US 64011504-05

Rocker Arm Prematurely Worn

– New rocker arms

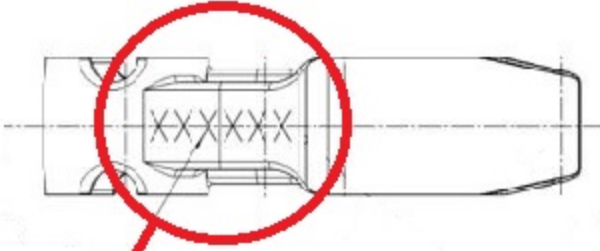
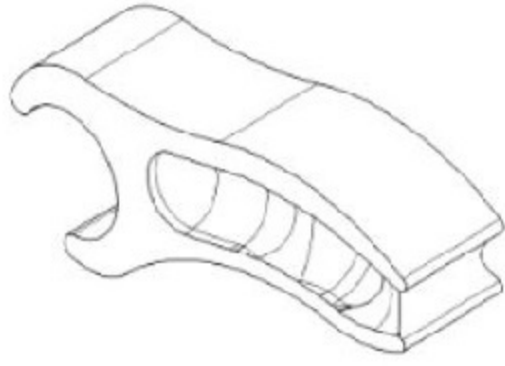
The coating of the new lever has additional layers, which have a damping effect and increase the robustness of the layers. Visually the new rocker arms differ considerably from the old ones, see attached image.

For all S-models (K46, K46/11, K46/12, K46/13, K47, K47/11, and K49) in a repair case, the new version rocker arms are to be installed. Also exchange ALL 16 rocker arms and both camshafts, engine oil and oil filter).

Order the following part number for the S-model rocker arms: 11 33 8 389 397.

Batch Number

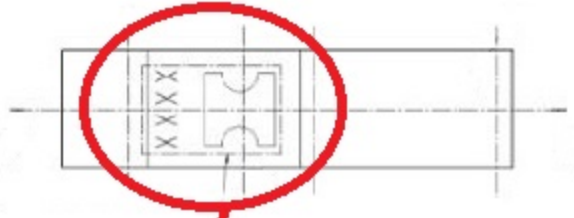
If problems re-occur with the new rocker arms, please inform us immediately using a TSARA case with informative photos, in which the batch numbers of the rocker arms (see attachment for batch number location) and the complaints are visible.
